UNITED STATES PATENT AND TRADEMARK OFFICE

09/674,600

Office Action Summary

DETAILED ACTION

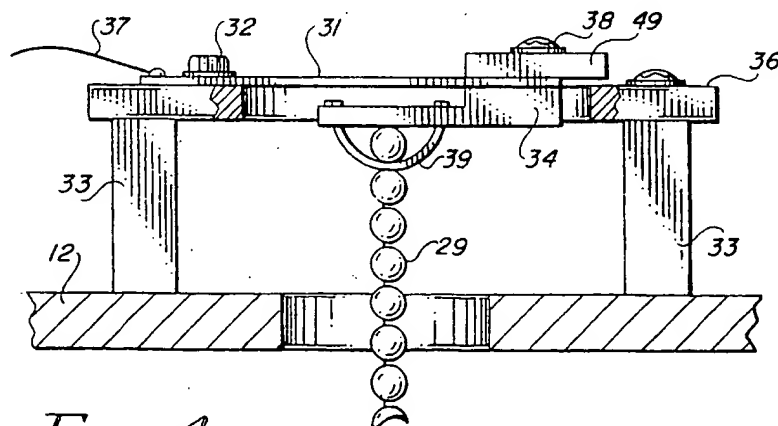
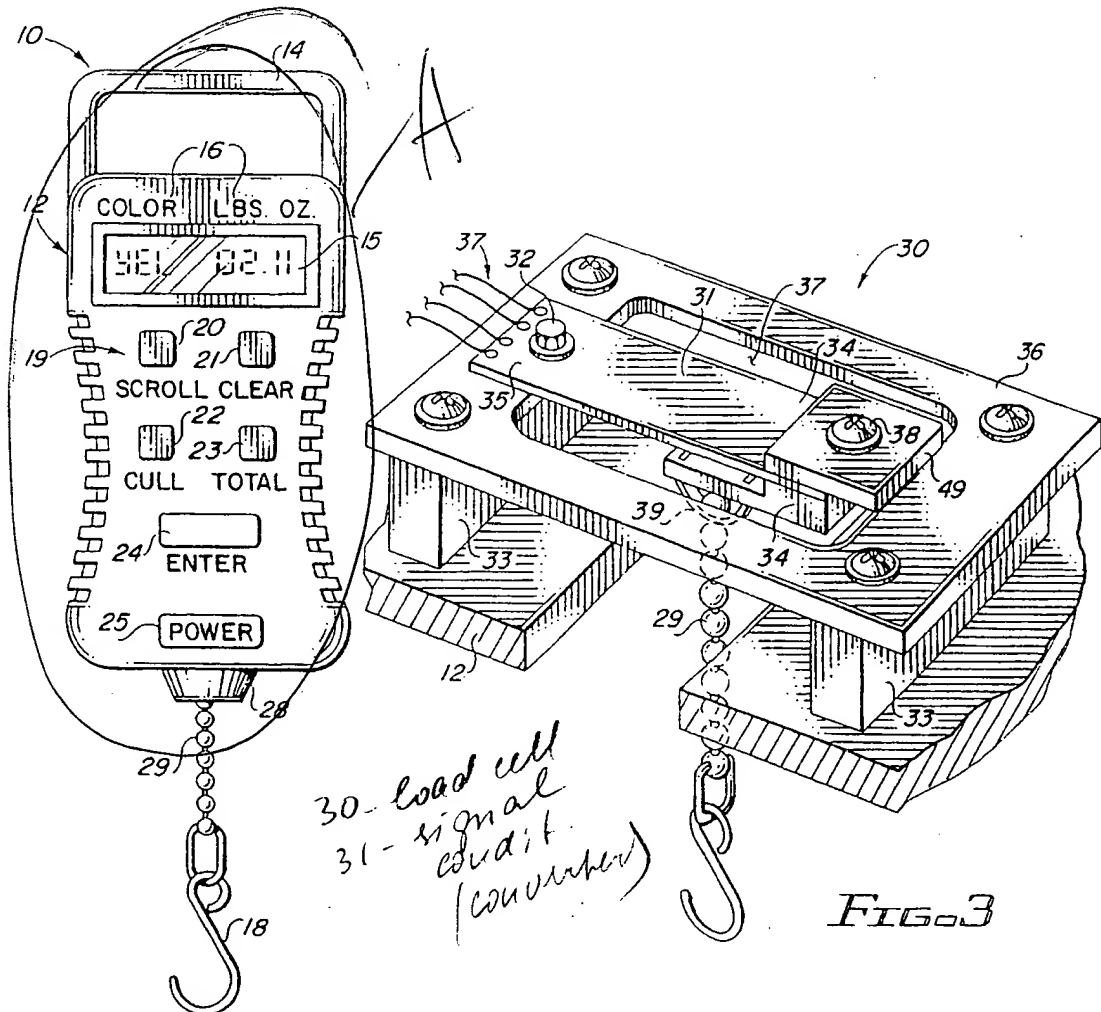
Stanfield discloses a tool (scale) 10 comprising a weighting hook (mechanical hand tool) 18 integrally attached by a hook and loop connection to a measuring and displaying device A, a load cell (measuring sensor/ scale/ weighting cell responding to a pressure) 30, a keypad 19, an electronics comprising a memory (storage device) to store data, a signal conditioning block (converter) 51 for converting a signal (weight/ physical value) in an electrical signal understandable by a processor (microprocessor) 52 which converts the signal in an electronic signal displayed on the display in appropriate units (pounds) on an LCD 15. The electronics is mounted integrally (hook and loop connection) to the hand tool (hook) and can be released. The device can be on/ off. The device is operated by a power supply in a form of battery. (the numeral A has been added by the Examiner, see attachment to the Office Action).
